# CITY OF TAMPA

## ADDENDUM 3 DATE: June 21, 2019

Contract 18-C-00009; 43rd Street Outfall Regional Stormwater Improvements

LOCATION: NORTH 43RD STREET TAMPA, FL  
LATITUDE: N 27° 57' 36.30"  
LONGITUDE: W 82° 24' 36.18"  
DRAWING NO: 1351 SHEET: 1 OF 2  
DRAWING DATE: 09/28/2012 LAST REVISED: 04/23/2018  
DRAWING SCALE: 1 INCH = 20 FT

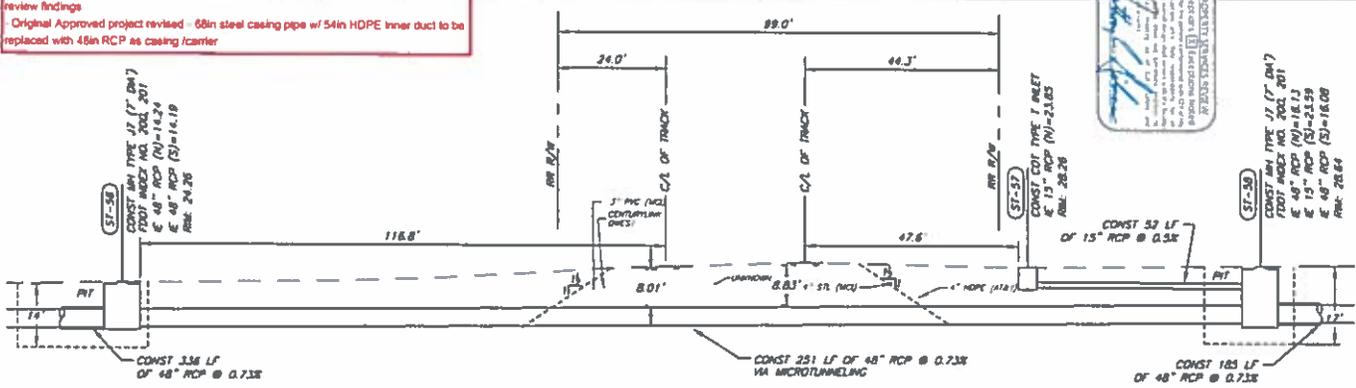
Reference conclusions and recommendations per Shannon & Wilson Feb 1, 2018 PE review findings  
Original Approved project revised - 68in steel casing pipe w/ 54in HDPE inner duct to be replaced with 48in RCP as casing/carryer

Reference conclusions and recommendations per Shannon & Wilson Feb 1, 2018 PE review findings.  
Original Approved project revised - 60in steel casing pipe w/ 54in HDPE inner duct to be replaced with 48in RCP as casing /carrier

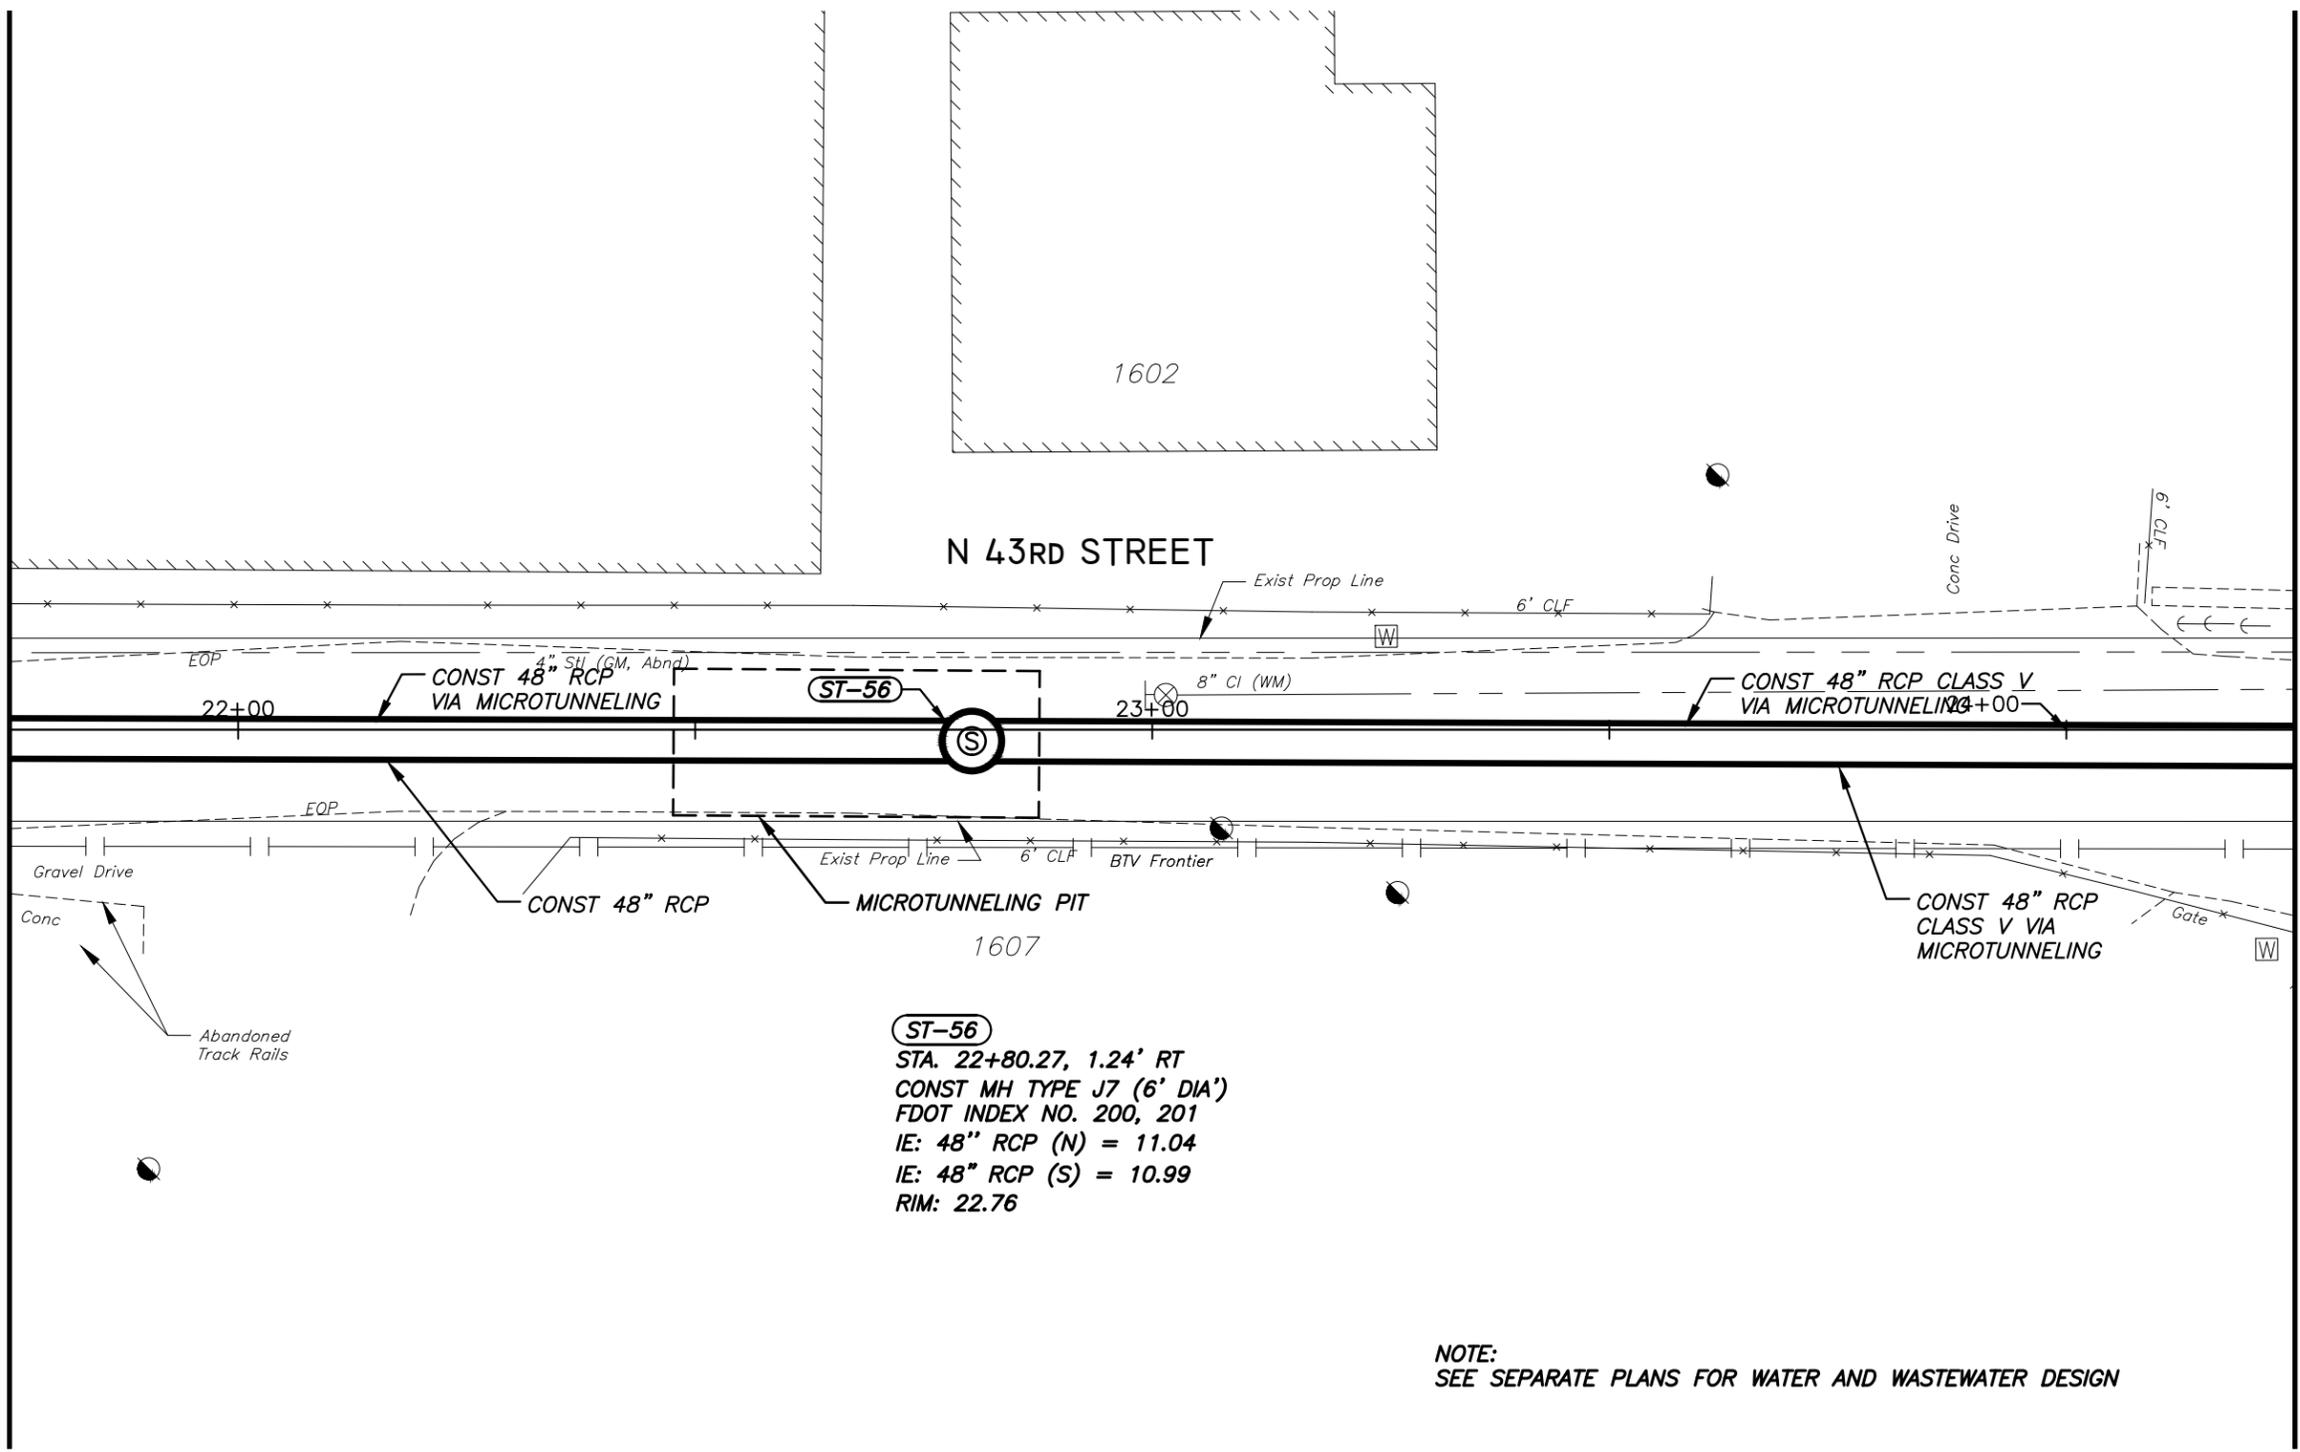
Item 7: Replace Plan Sheets 29 and 31 with the attached Plan Sheets 29 and 31.
